P 524451

ON-SITE SEWAGE DISPOSAL SYSTEM HOWARD COUNTY HEALTH DEPARTMENT BUREAU OF ENVIRONMENTAL HEALTH

ADDRESS: 6694 Luster Drive PROPERTY OWNER: Alan Posey

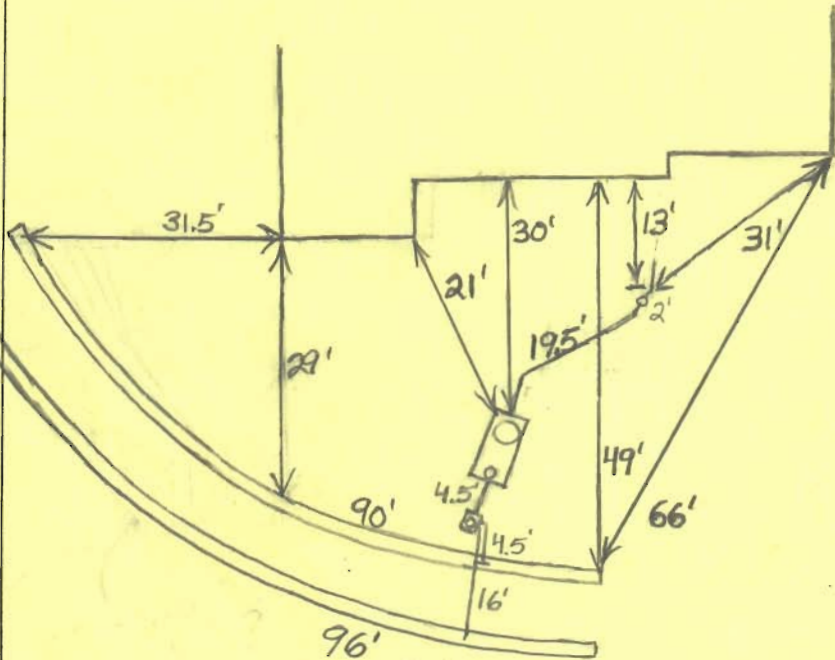
SEPTIC TANK CAPACITY (GALLONS): 1000+500? Homeowner Considering a Bedroom Addition in Future

NUMBER OF BEDROOMS: 4 but size for 5 for Future Addition.

LINEAR FEET OF TRENCH REQUIRED: _____
4 Bedroom - 149'
5 Bedroom - 186'

TRENCHES:	Trench to be <u>3'</u> feet wide. Inlet <u>5'</u> feet below original grade. Bottom maximum depth <u>7'</u> feet below original grade. Effective area begins at <u>3.5'</u> feet below original grade. <u>2'</u> feet of stone below distribution pipe.
LOCATION:	<u>Will Have to Add Additional 500 Gallon Tank or New 1500 2-Comp For Bedroom Addition</u>
PURPOSE:	Existing septic system has failed. Call for inspection when ground is opened so sanitarian can recommend repair. <u>Any Tanks Must Be 20' From Addition</u>

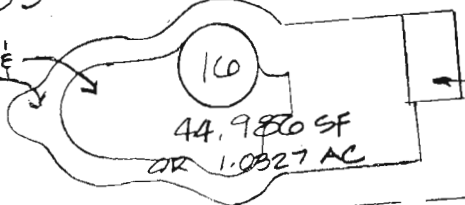
PRE-CONSTRUCTION 5/18/06 Owner wishes to build future garage addition and possibly bedroom addition. New 1500 gallon tank installed and system to be sized for 5 bedrooms. Top 90' trench installed. Lower trench supposed to be slightly longer but still 100' from neighbor's well. (BB)

5/19/06 Gave Hatfields permission to cover lower trench. Can't make it to final inspection. Hatfields to call back with trench length. (BB) 6/2/06 I spoke to Jeff. He said

that lower trench was 96' in length. (BB)
